Customer Service Bulletin

Units Affected:

SVT-2PROJ units serial numbered T2PJJ40001 through T2PJJ40042

SVT-CLJ units serial numbered TCLJJ40001 through TCLJJ40032

07-319-xx AC Termination board as viewed from inside lower chassis

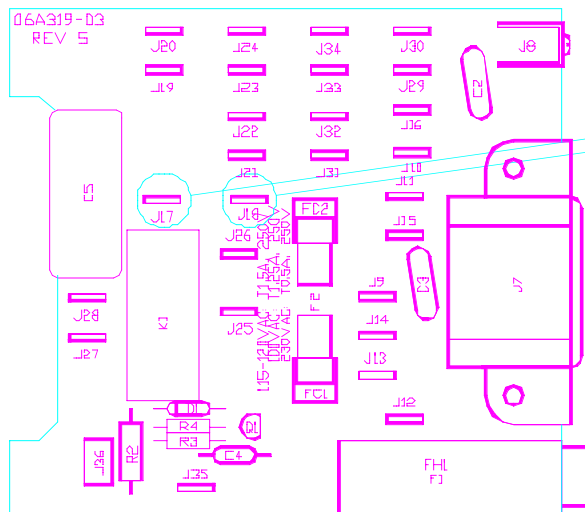
AC mains fuse for filament transformer would fail prematurely during normal operation when tuning unit on as a result of a design change to use IEC approved fuse beginning with 1/1/97 production. Replacement with larger value fuse would solve false tripping problem but would not always provide adequate protection against damage during severe fault condition.

Add two each 3A in-rush current limiters (ICL's) that have been prepared with .187" Fast-on connectors (SLME part number 97-123-23) to the filament transformer primary circuit as follows:

1. Disconnect the AC power from the unit.
2. Remove lower chassis assembly from cabinet and view from bottom.
3. On the 07-319-xx AC termination PC board, remove blue and gray leads from tabs J17 and J18.
4. Add one 97-123-23 ICL assembly in series with the blue transformer lead and tab J17, and one in series with the gray lead and J18 by attaching the female Fast-on connector of ICL to the tab on the printed circuit board and the male Fast-on to transformer lead.
5. Secure the assembly with a cable tie to other AC wires so that no leads are touching other parts.
6. Replace the fuse (F2) with a T1.25A (SLME part number 23-512-05).
7. Remove any fuse label so that "100VAC T1.25A" is visible on the printed circuit board.
8. Reassemble and check out unit for proper operation.

Add one 97-123-23 ICL assembly in series with J17 and the blue transformer lead and one in series with J18 and the gray transformer lead.
